# UNITED STATES PATENT AND TRADEMARK OFFICE

<b>Office Action Summary</b>	<b>Application No.</b> 10/797,581	<b>Applicant(s)</b> BECK ET AL.	
	<b>Examiner</b> Todd M. Epps	<b>Art Unit</b> 3632

This is the seventh Office Action for serial number 10/797,581, Computer Workstation With Moveable Monitor Support, filed on March 10, 2004.

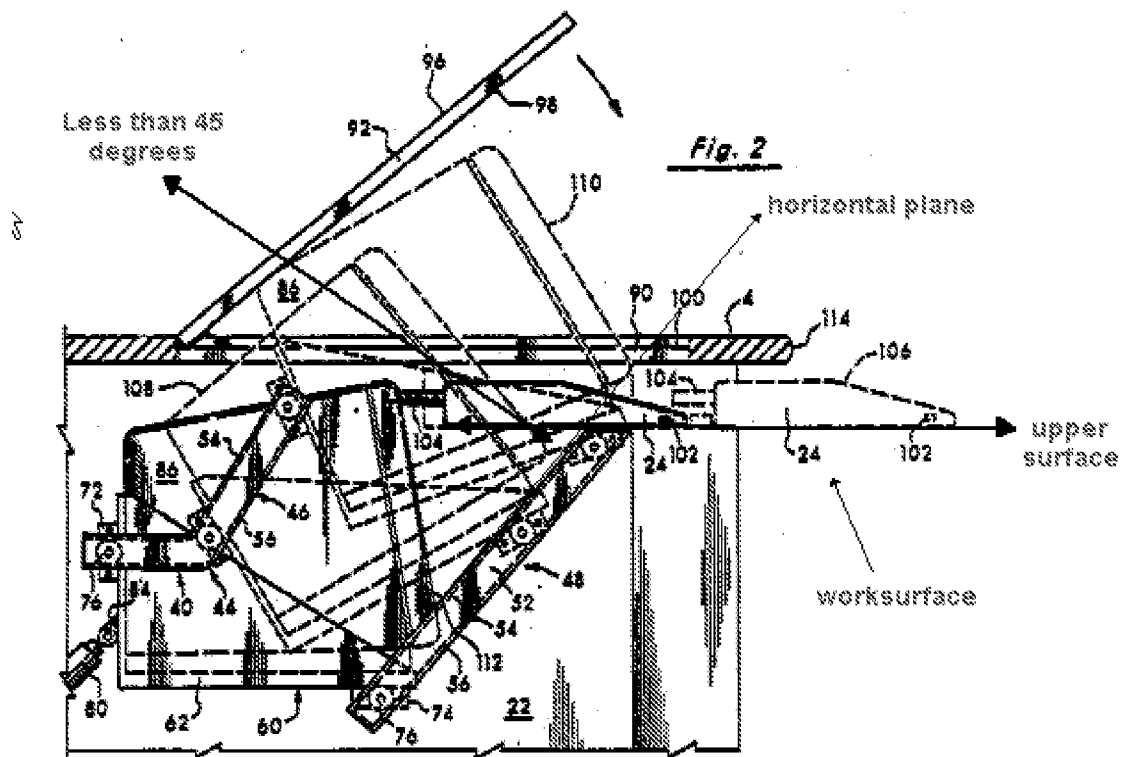
Price '773 discloses a computer workstation comprising: a worksurface (24) moveable a first distance in a fore-and-aft direction between first and second worksurface positions; wherein a support surface of the worksurface forms an angle between about 5 to 45 degrees with a horizontal plane (see Figure 2 below); a monitor support (60) coupled to the worksurface, wherein the monitor support is automatically moveable in response to a movement of the worksurface, wherein the monitor support automatically moveable a second distance in fore-and-aft direction between first and second monitor positions in response to the worksurface being moved the first distance between the first and second worksurface positions; wherein the second distance is greater than the first distance; a base (desk) having an upper surface formed at substantially with the horizontal plane, and wherein the base supports the worksurface.

Furthermore, Price '773 disclose wherein the monitor support defines a support place (62) and further comprising at least one track oriented non-parallel (40, 42) to the support plane, and a guide (76) moveably mounted on the track, wherein the monitor support is pivotally connected to the guide; wherein the worksurface is connected to a front of the monitor support; and wherein the at least one track comprises at least one first track (46) directed upwardly from a rear to a front thereof and at least one second track (44) directed downwardly from a rear to a front thereof; wherein the second track is positioned forwardly of the first track and further comprising a first guide (76) moveably mounted to the first track and a second guide (76) moveably mounted to the second track, wherein the monitor support is pivotally connected to the first and second guides, wherein the monitor support rotates about a horizontal axis as the first and second guides are moved along the first and second tracks respectively.
